Addendum No. 5

Date: April 26, 2013

Reference: Regional Training Institute – TASS Phase 2
Utah National Guard – Camp Williams, Utah
DFCM Project No. 11020480

Subject: **Addendum No. 5**

1 SF102 SECOND FLOOR FRAMING PLAN
SCALE: 1/8" = 1'-0"

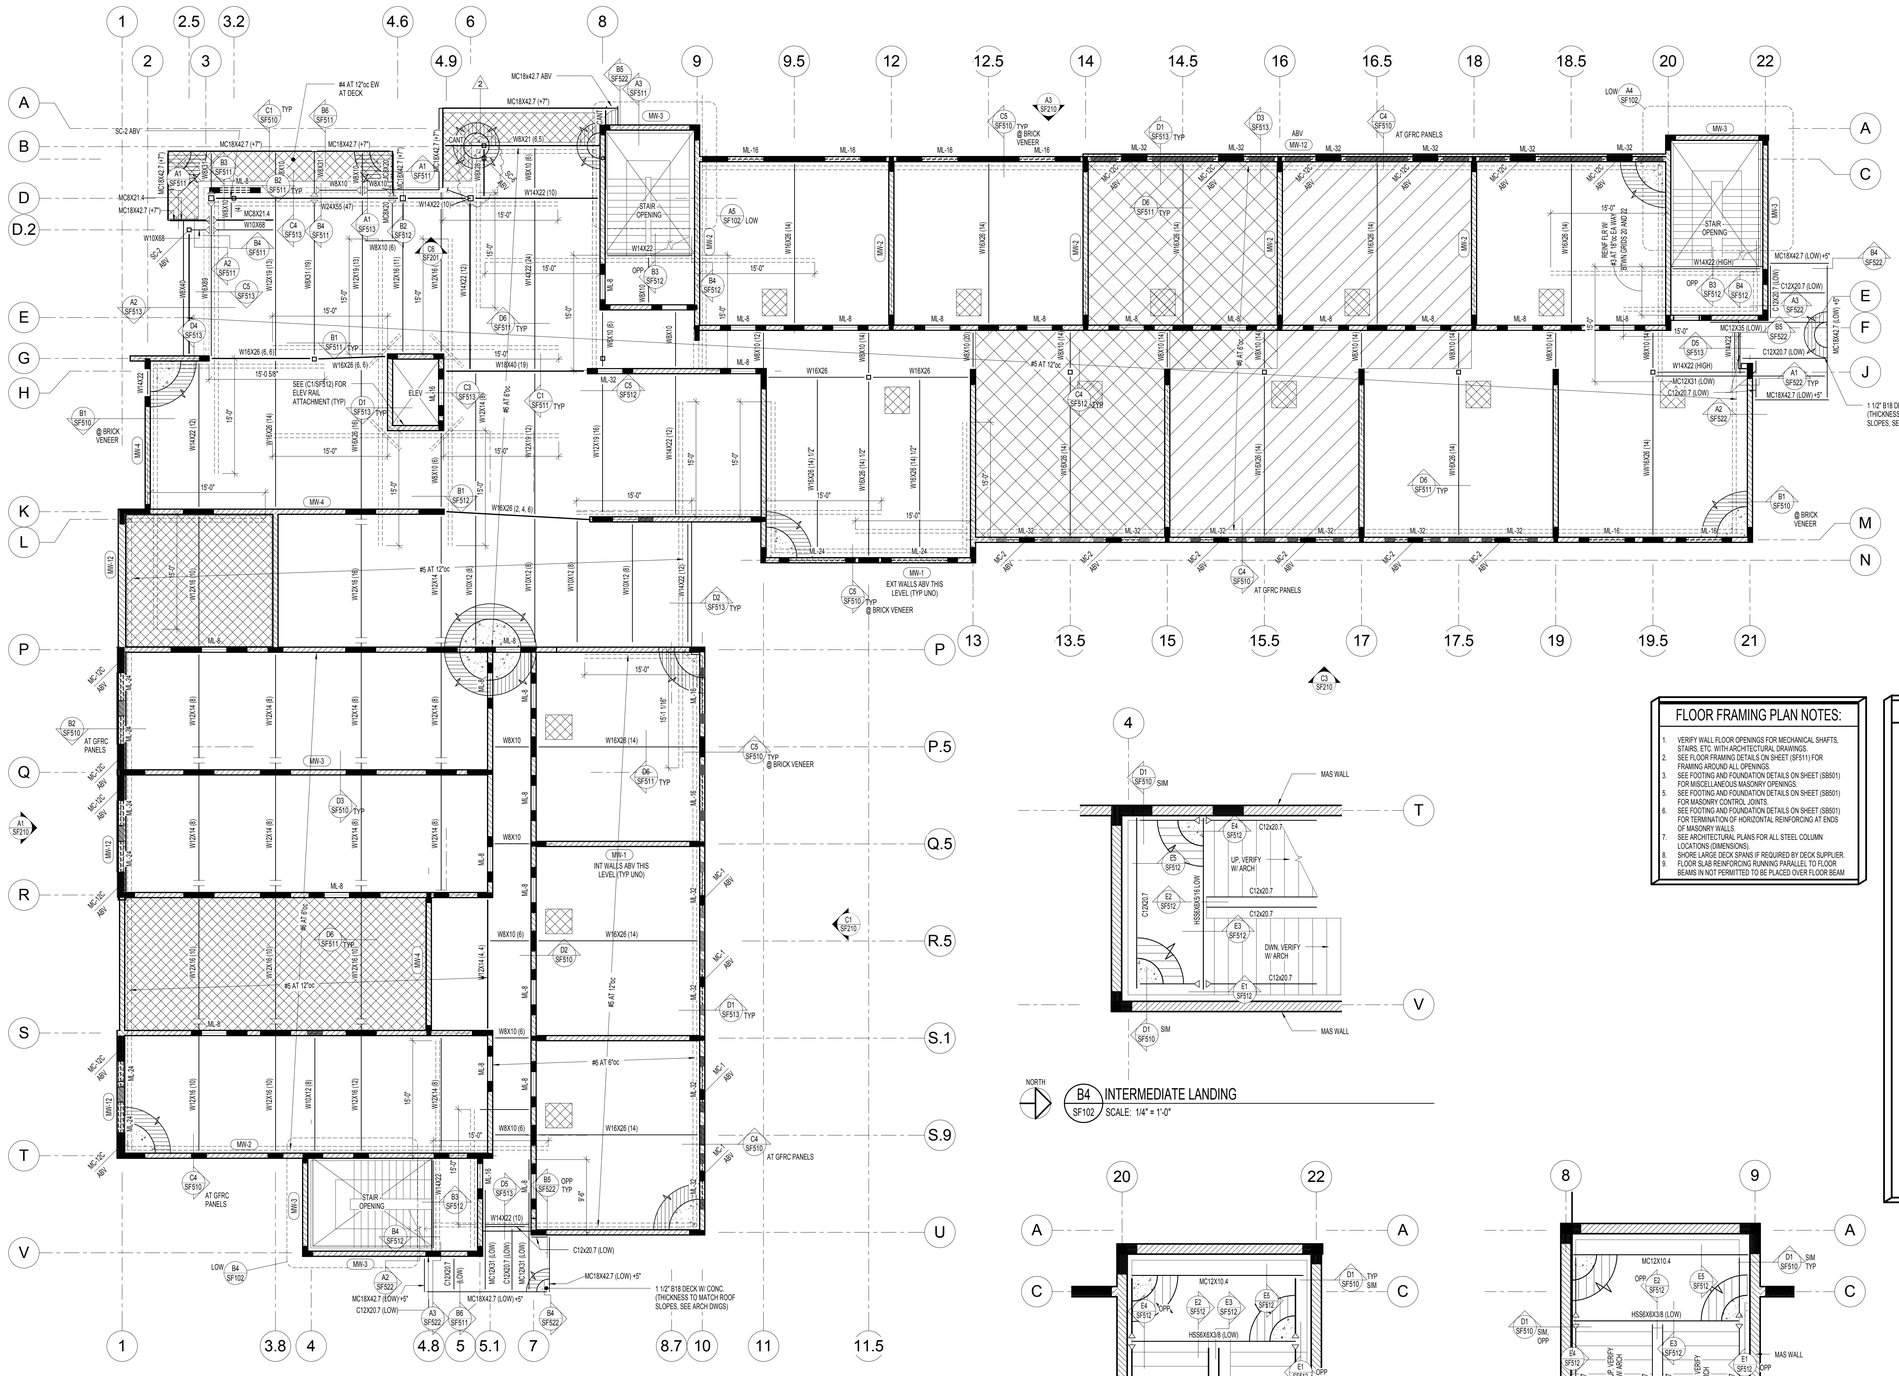
1. Drawing SF102 – Revised W8x18 floor beam to W8x28.

A1 AE111 BILLETS LEVEL 1 FLOOR PLAN
1/8" = 1'-0"

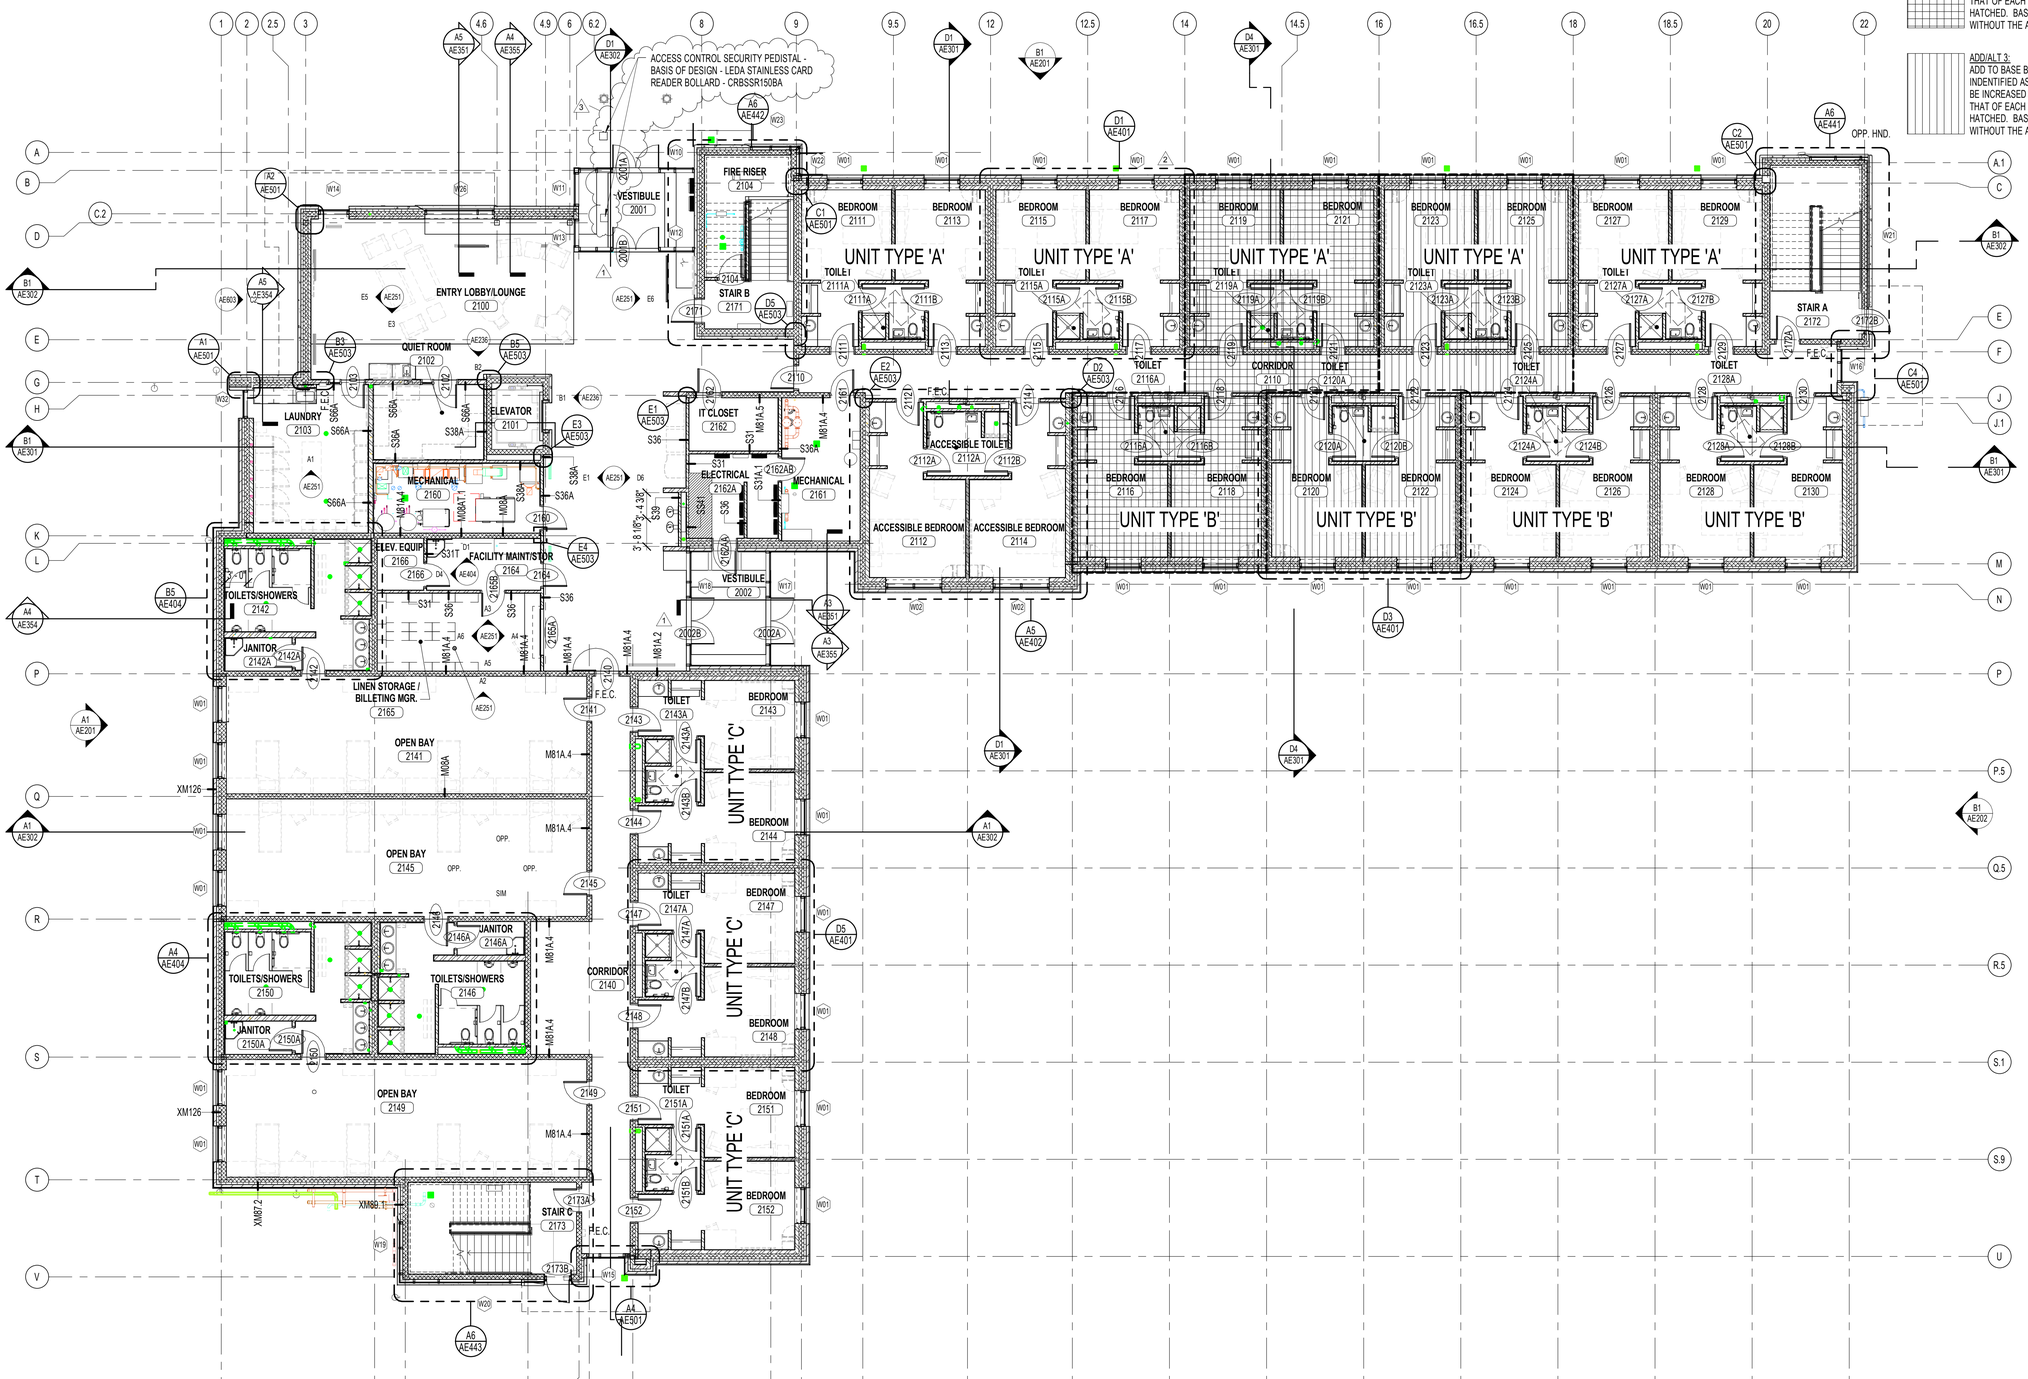
Item #	Sheet(s)	Amendment
B3.01	AE111	**REVISE** floor plan A1/AE111 as shown on sheet provided. Locations of pedestals for access control card reader and automatic door operator push pad for door 2001A, and automatic door operator push pad for door 2001B.
B3.02	AE201, AE202	**REVISE** building elevation keynote #1 to read as follows: *"PAINTED STEEL CHANNEL"* **REVISE** building elevation keynote #2 to read as follows: *"METAL PANEL SYSTEM"*. This metal panel system is to match Administration building zinc metal panels.

C2 AE603 WINDOW TYPE W31 1/4" = 1'-0"

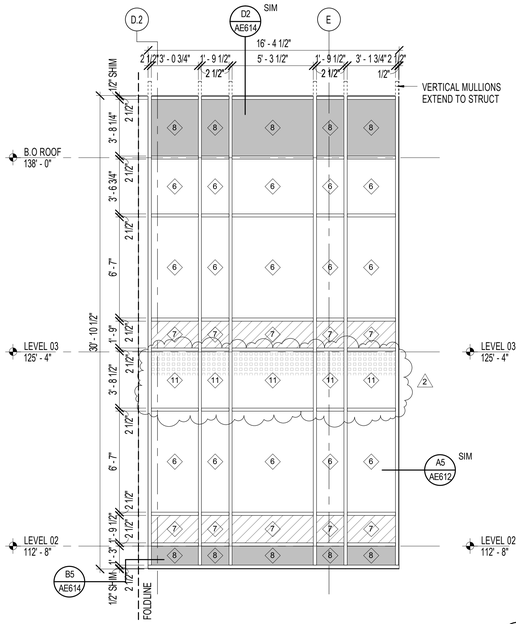
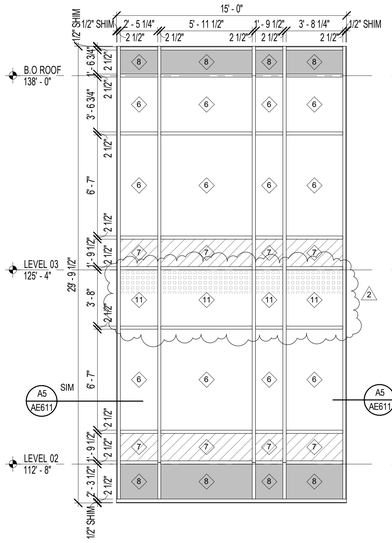
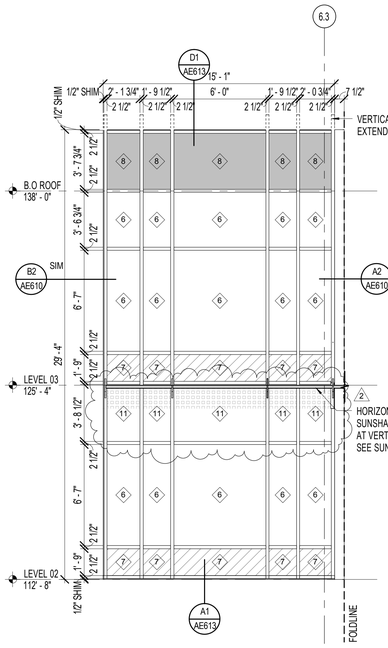
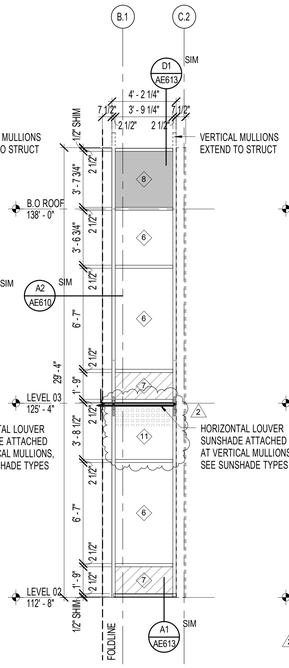
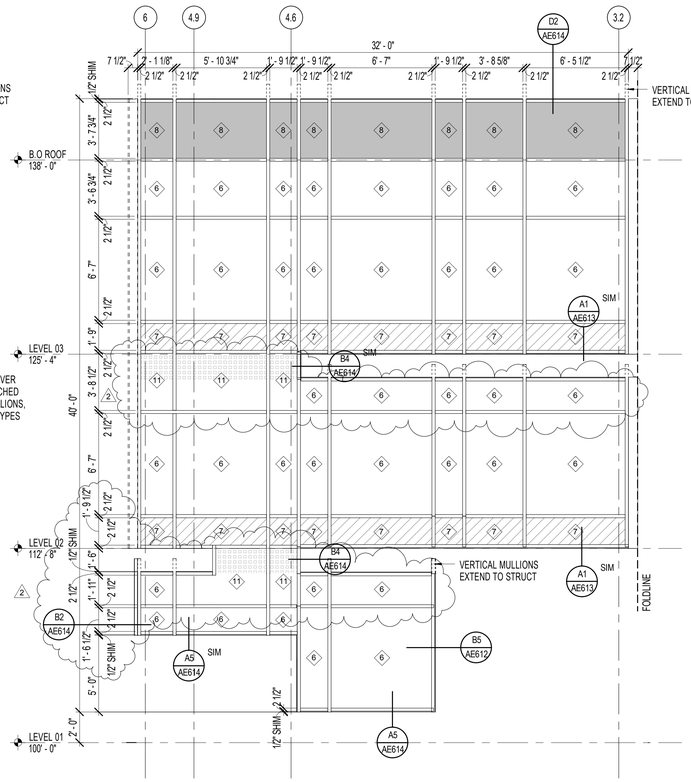
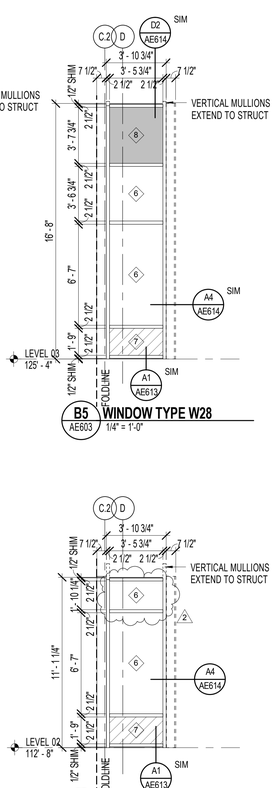
Item #	Sheet(s)	Amendment
B3.03	AE603	**REVISE** curtainwall window type elevations A1, A2, A3, A5, A6, C2, C3, C4, C5, and C6/AE603 as shown on sheet provided. Some glass panels changed type, while the remainder of revisions now show better the delineation of the graduated frit patter for glass type 11.
B3.04	AE610	**ADD** glass detail D2/AE610, as shown on sheet provided. Detail shows custom fritting pattern for glass type 11.

C4 FP101 LEVEL 3 FLOOR FRAMING - FIRE PROTECTION PLAN
1/16" = 1'-0"

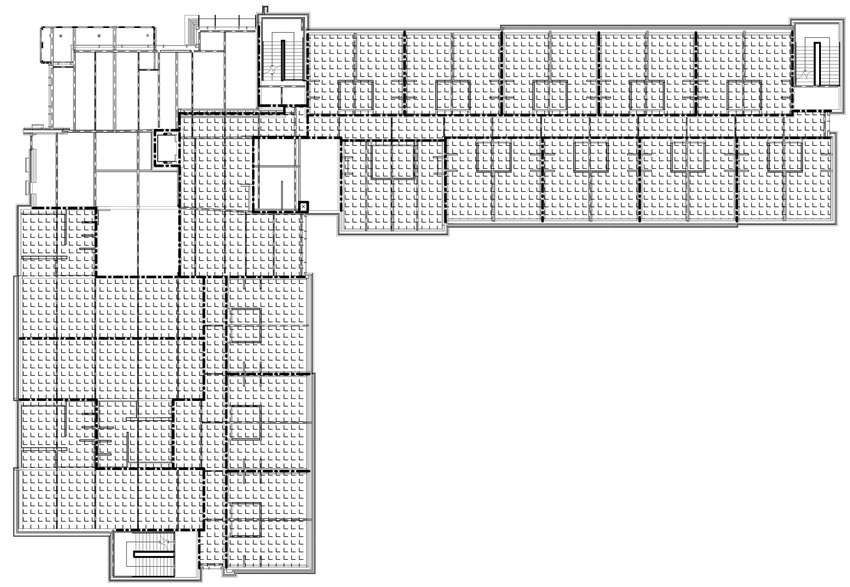
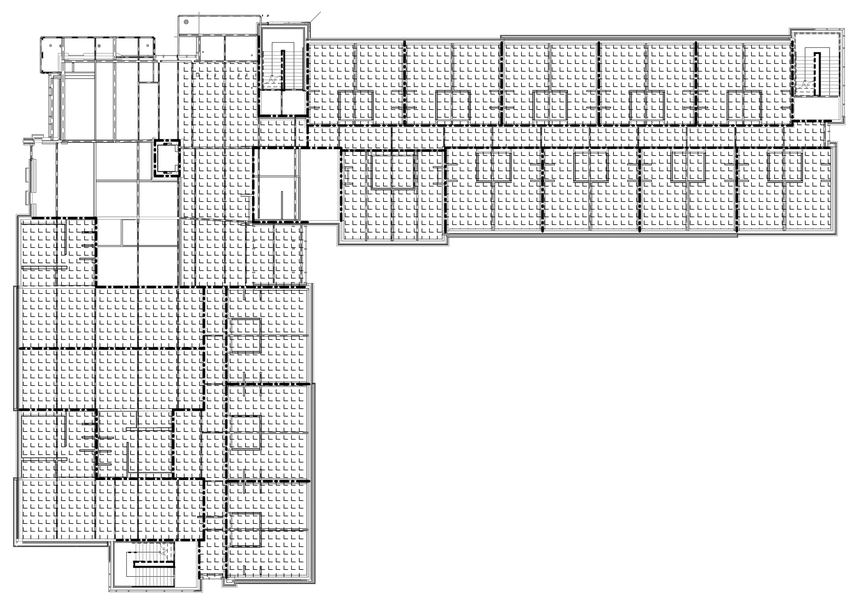
Item #	Sheet(s)	Amendment
B4.01	FP101	**ADD** sheet to construction documents, as provided herein.

20. Addendum #4 adds section 07 81 00 Applied Fireproofing, please provide plans that indicate where this will be applied. Specifications only mentions Metal decks. Under exposed deck? Under all deck? Under exposed roofing deck or all? Column connections with beams at exposed places or all? Metal staircases? Columns, exposed or all? Does this apply to both buildings?
    a. ***No. Only in accordance with UL Design No. D974, as shown in Volume B, sheet GI513. This only applies to Billets building (Volume B).***

1 LEVEL 1 POWER PLAN
EP101 1/8" = 1'-0"

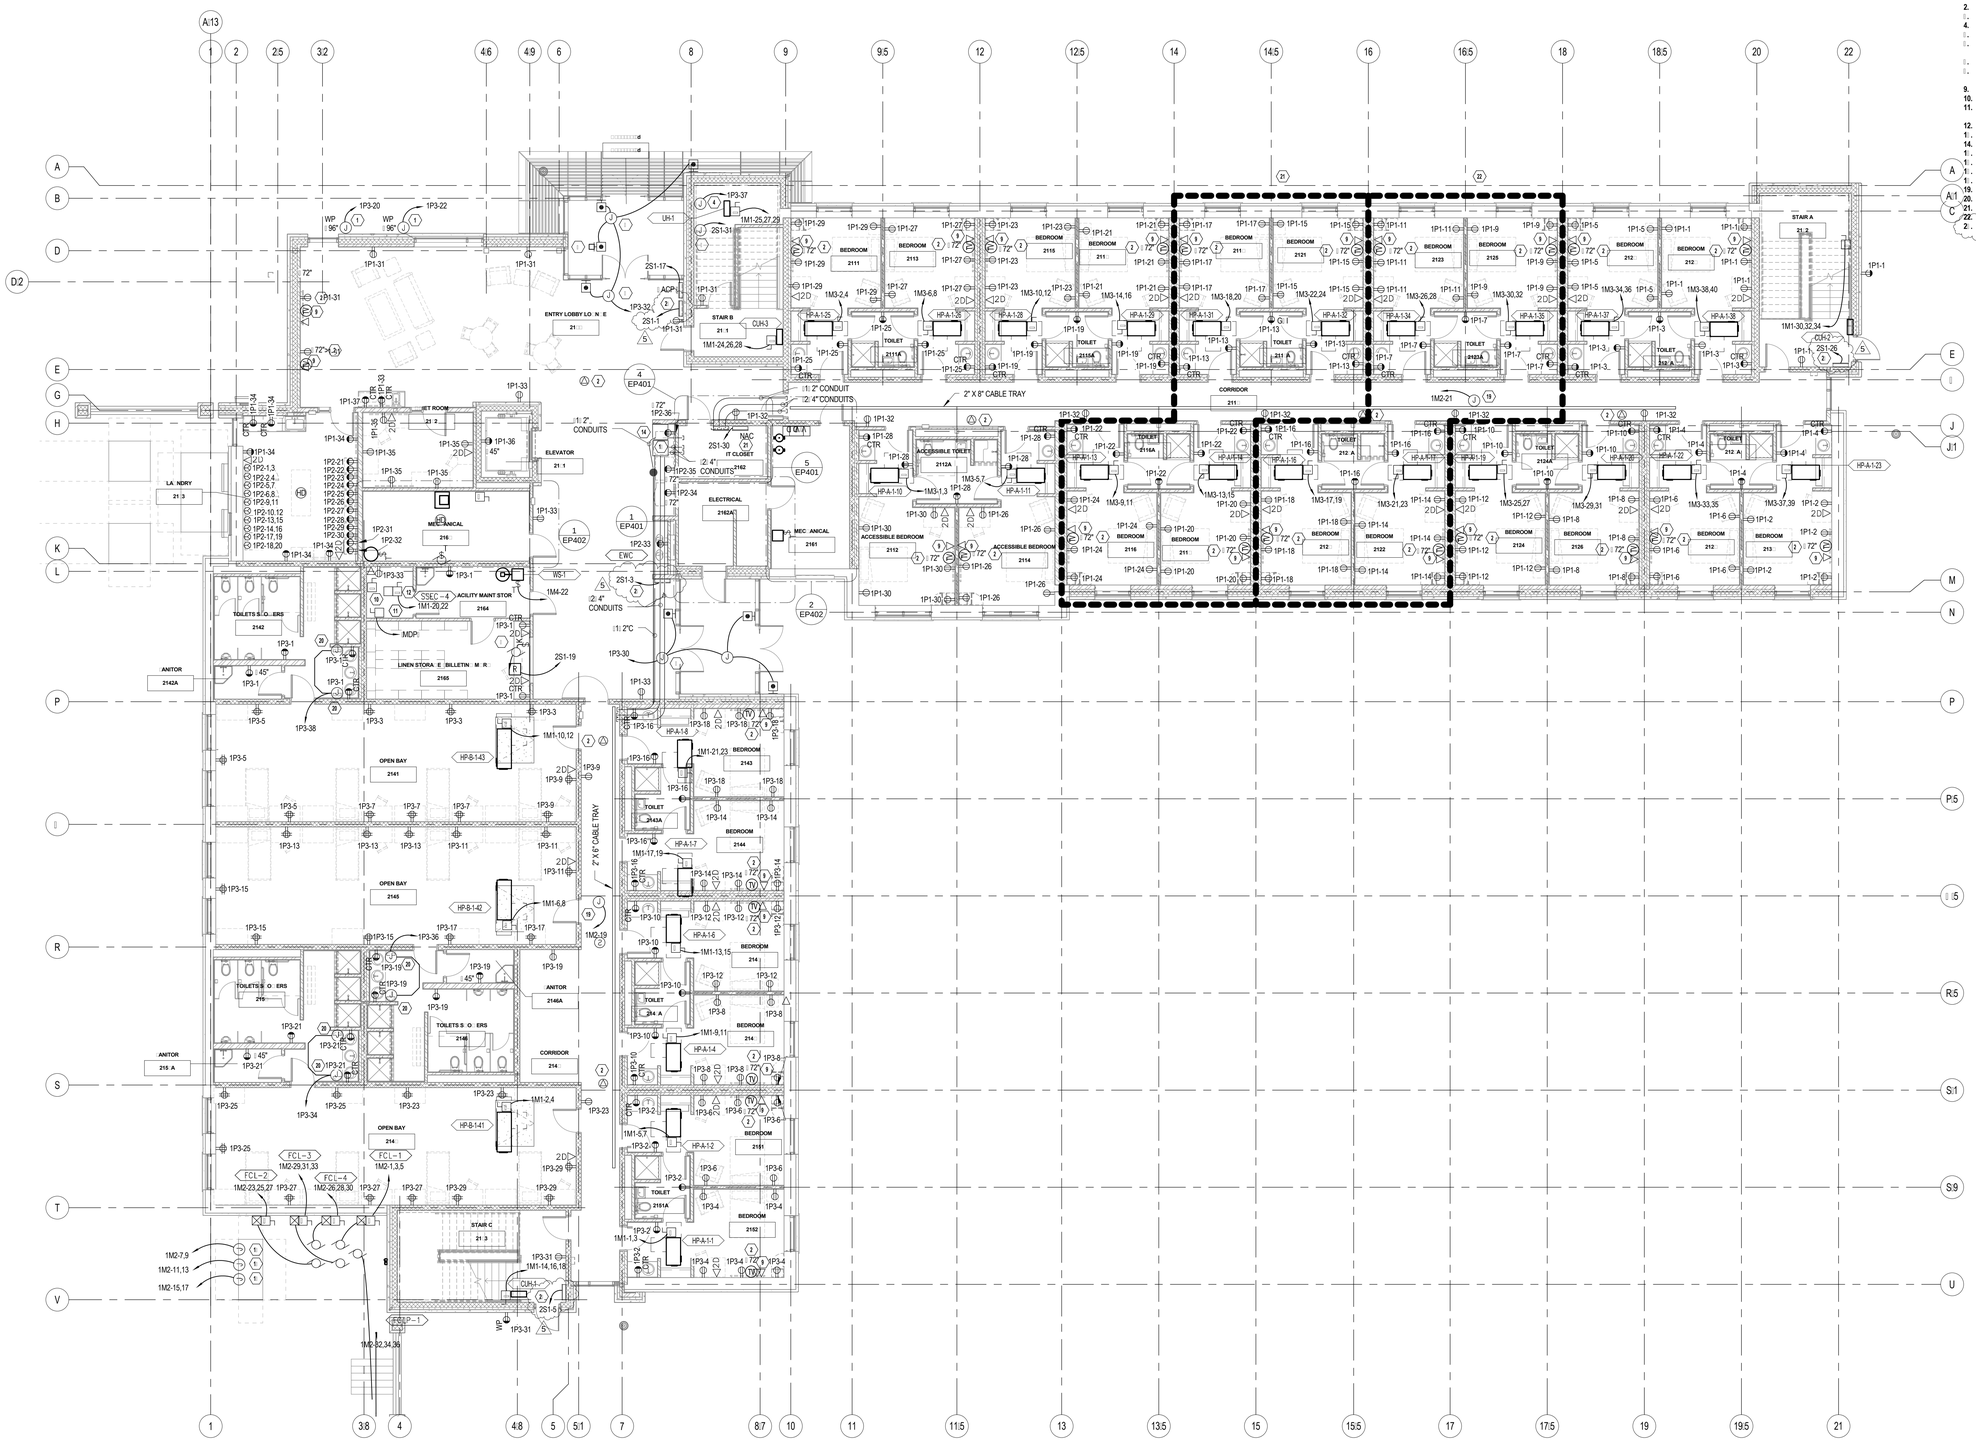
Sheet EP101
1. Add (4) mass notification announcement stations as shown on plans
2. Add keyed note stating, “mass notification voice station”
